January 24, 1992  
LD-92-006

Docket No. 52-002

Subject: Response to NRC Requests for Additional Information

RESPONSE TO NRC REQUESTS FOR ADDITIONAL INFORMATION  
PLANT SYSTEMS BRANCH

Figure  
9.2.1-1

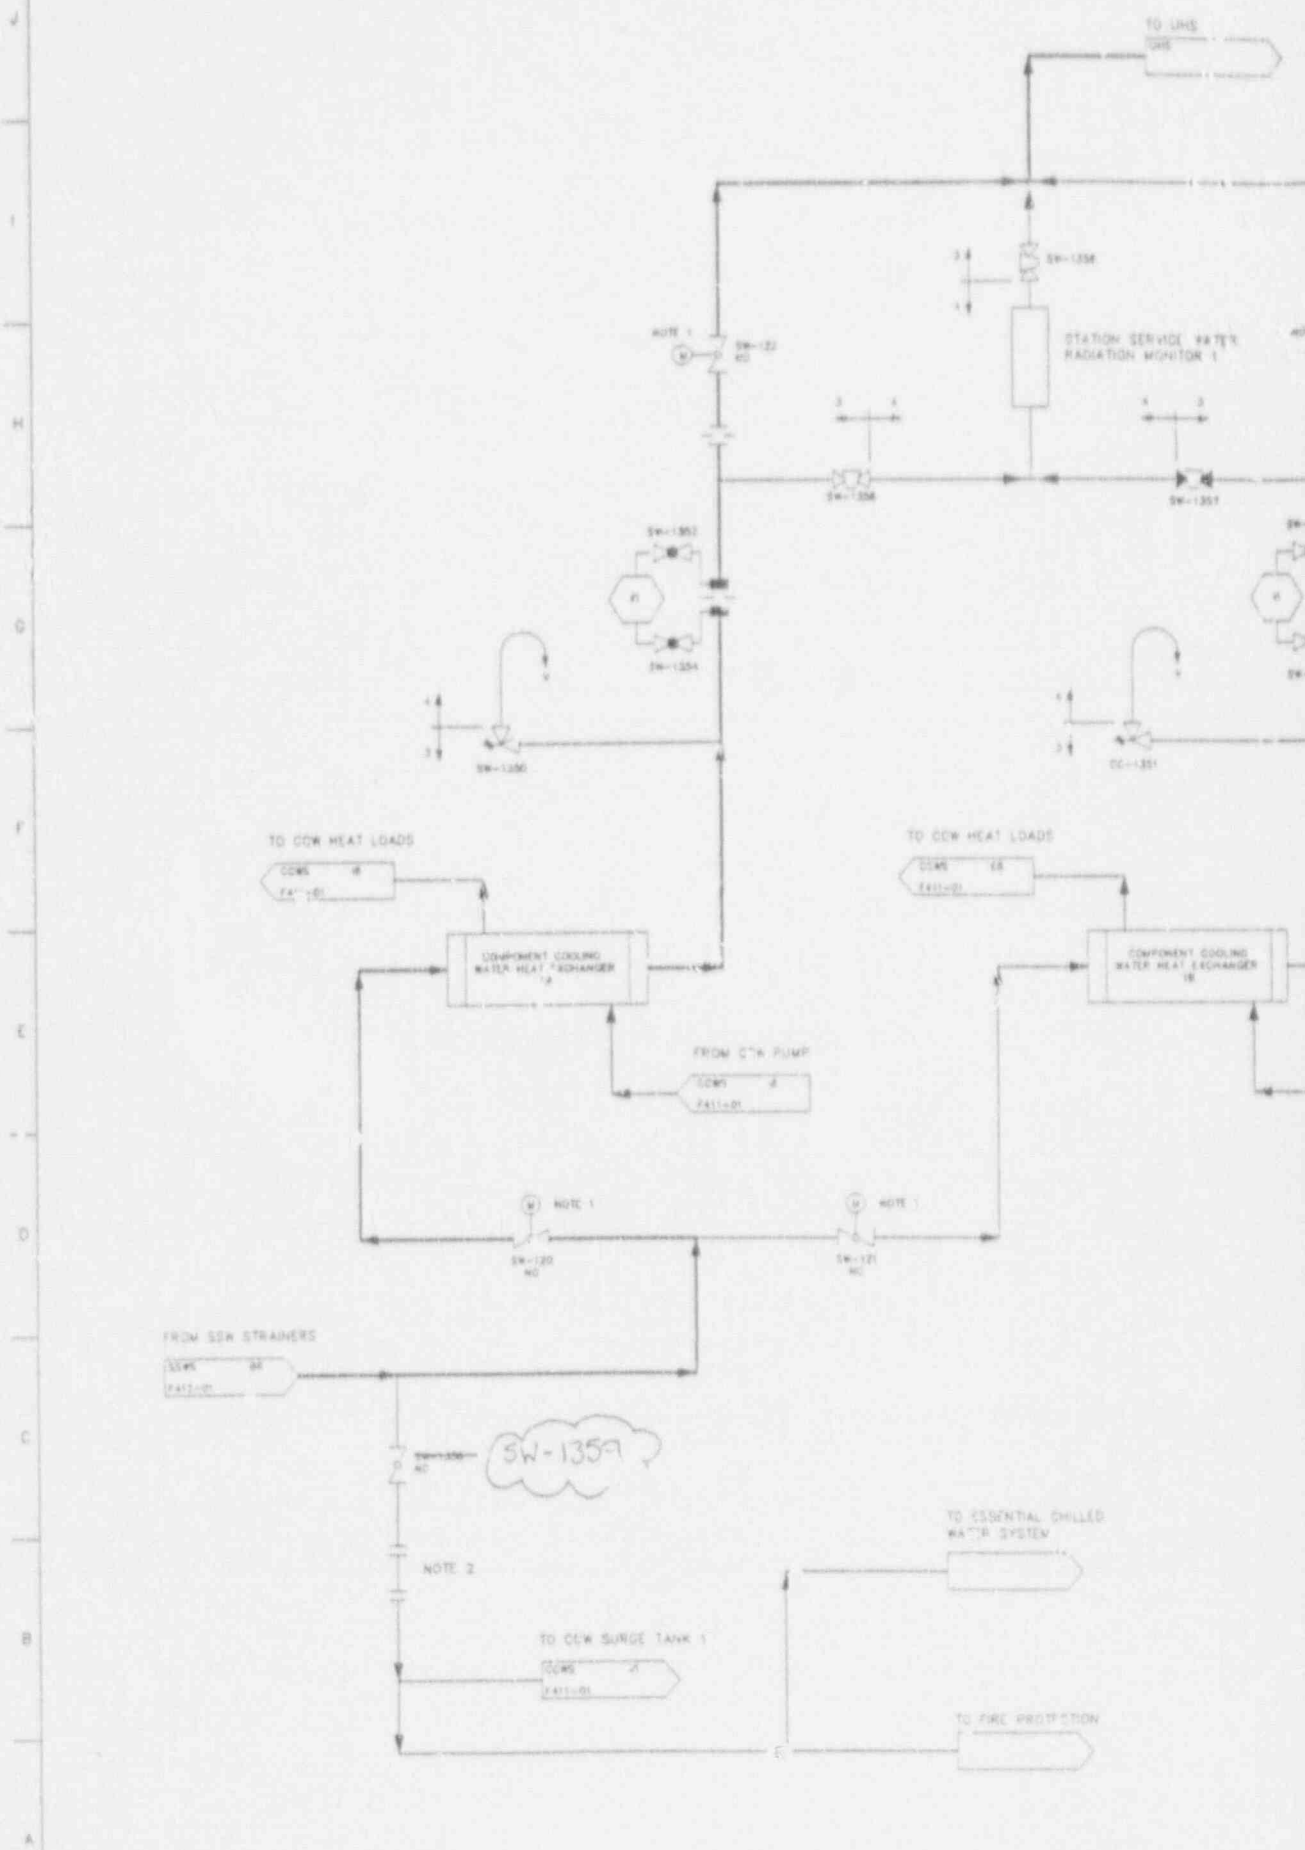
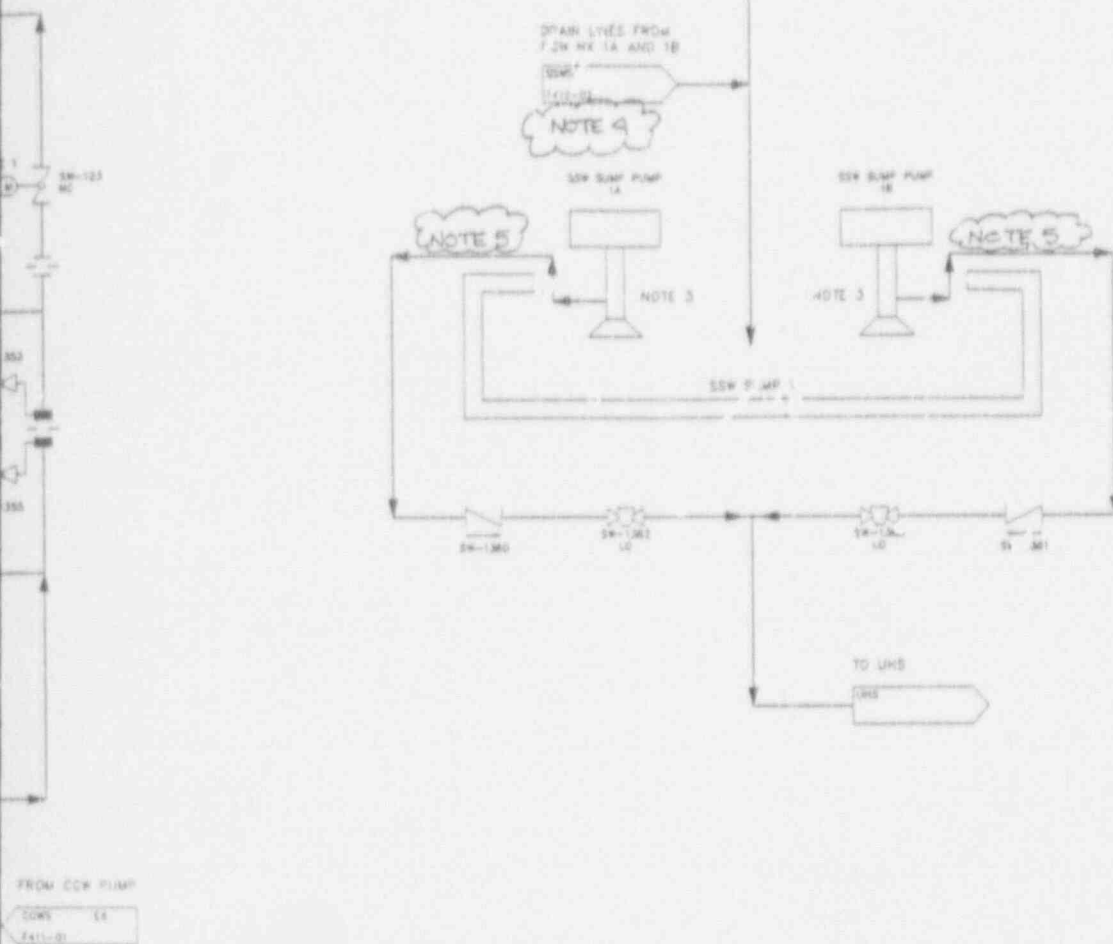
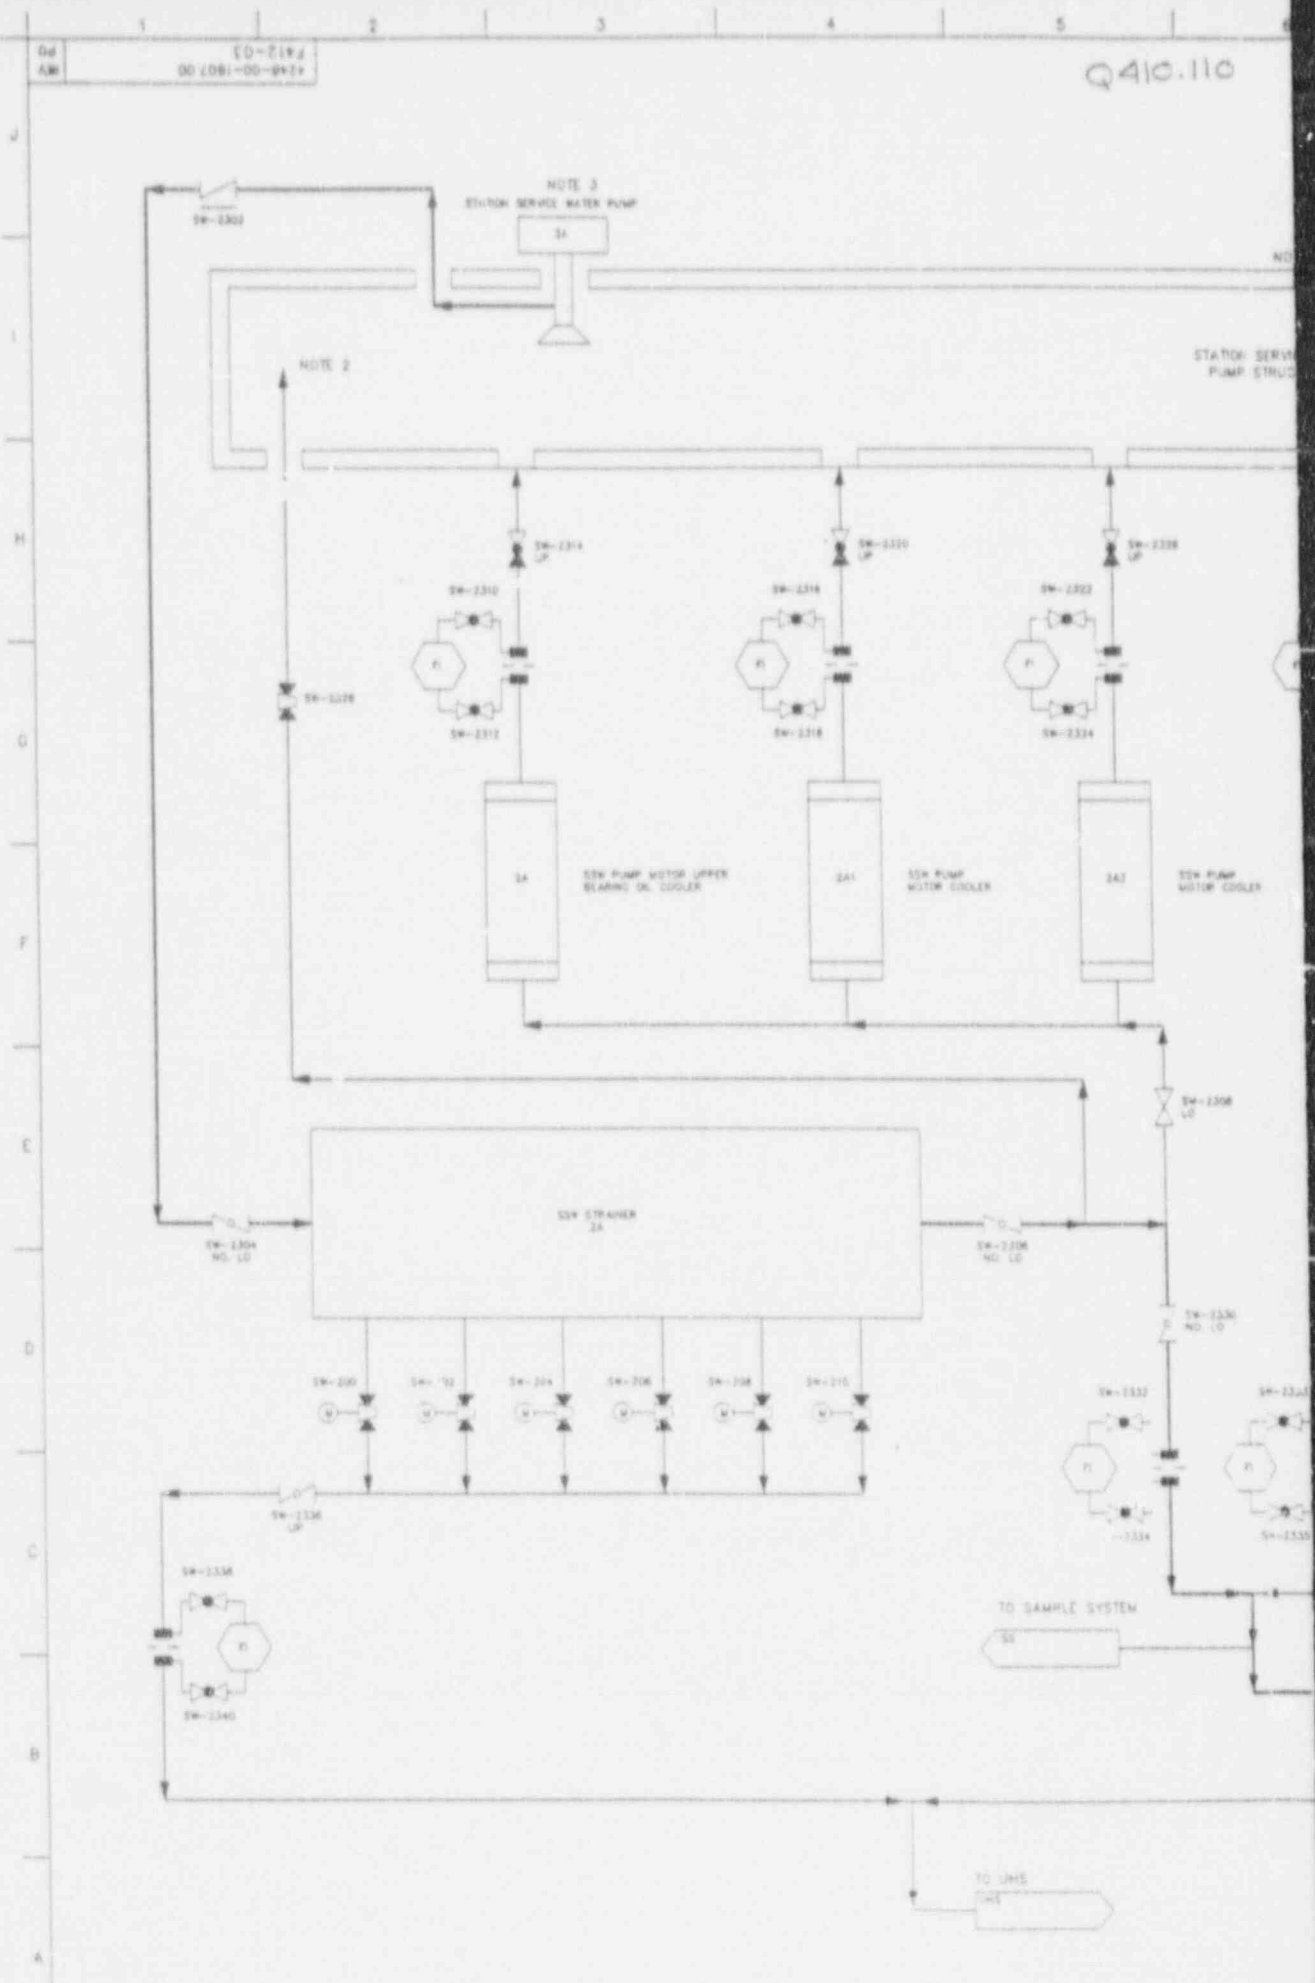
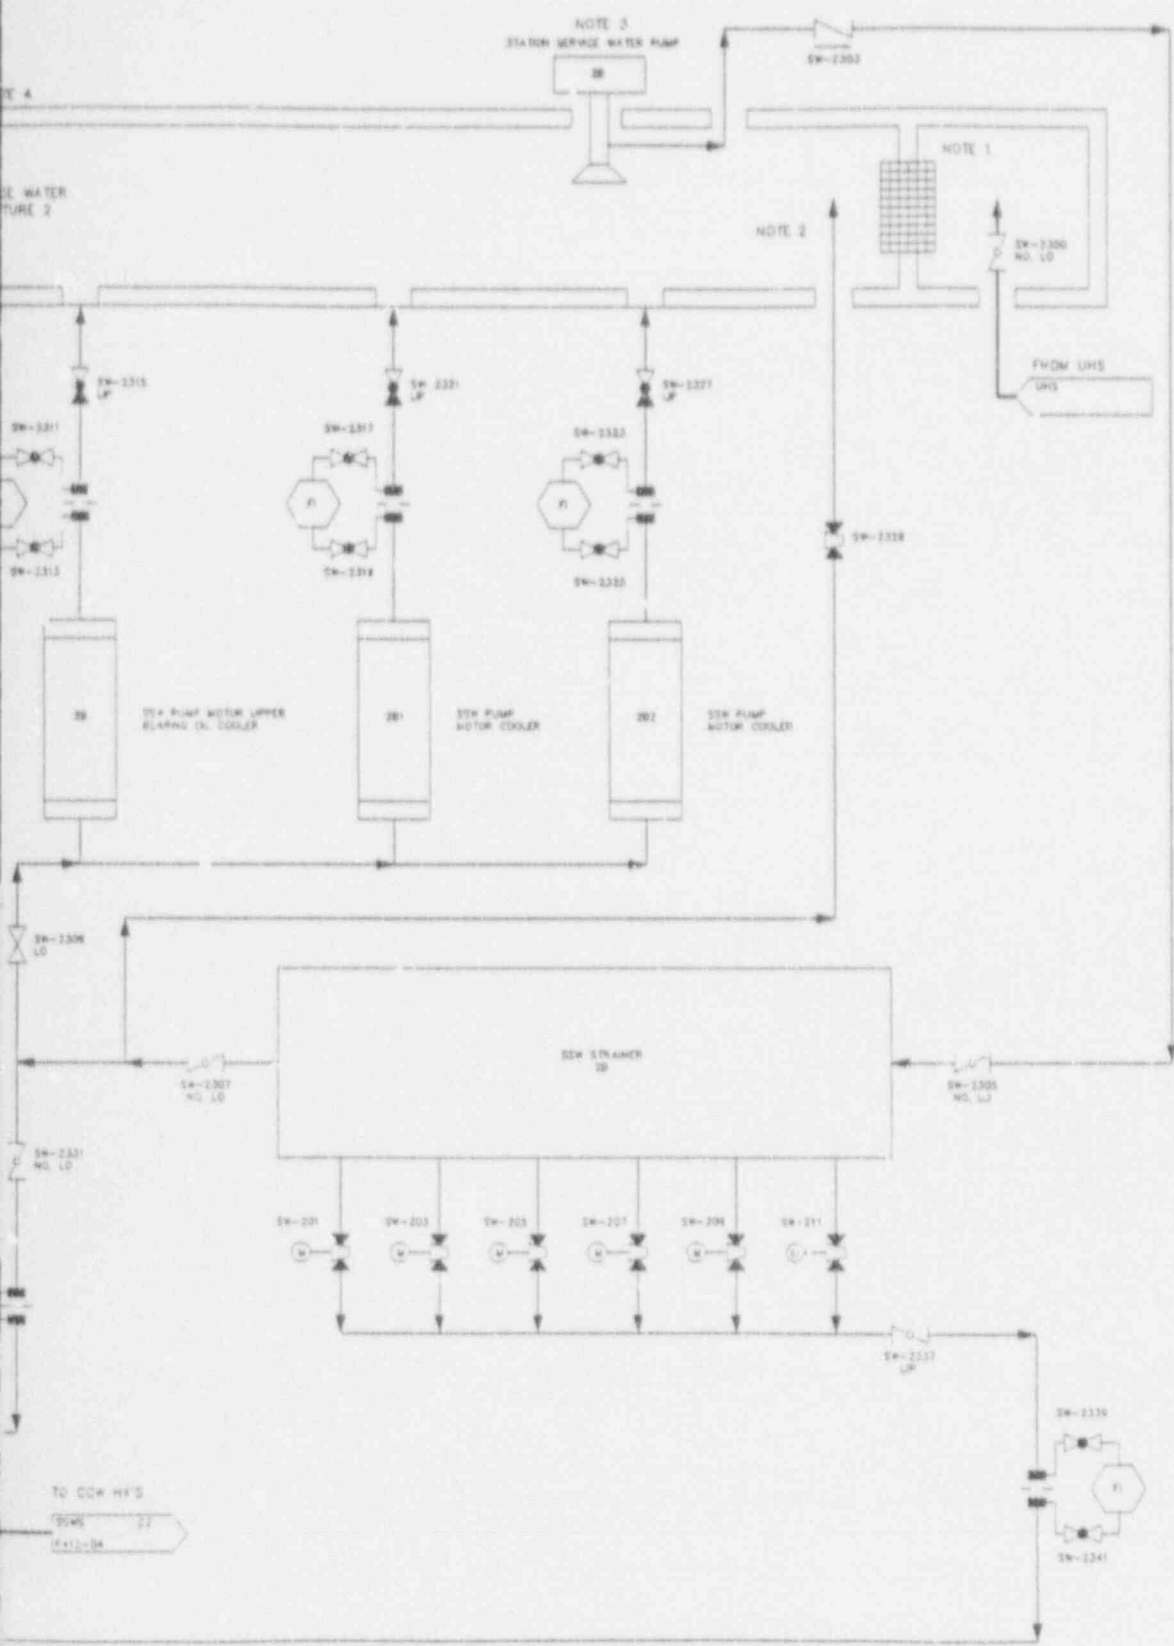
- c. Sheet 1 of Figure 9.2-1 identifies two valves that have been assigned the same number (i.e., SW-1356). A similar condition exists on Sheet 3 of Figure 9.2-3 with valve number SW-2356.

- c. The repetition of valve numbers SW-1356 occurs on Sheet 2 of Figure 9.2.1-1 and the repetition of valve number SW-2356 occurs on Sheet 4 of Figure 9.2.1-1. The valve numbers of the valves upstream of the removable spool piece should be changed to SW-1359 on Sheet 2 of Figure 9.2.1-1 and SW-2359 on Sheet 4 of Figure 9.2.1-1.

This response is being incorporated into CESSAR-DC Section 9.2.1, Station Service Water System. This response is reflected on the Station Service Water System Flow Diagrams as valve number changes on the valves upstream of the removable spool pieces. A markup of CESSAR-DC Figure 9.2.1-1 is attached.
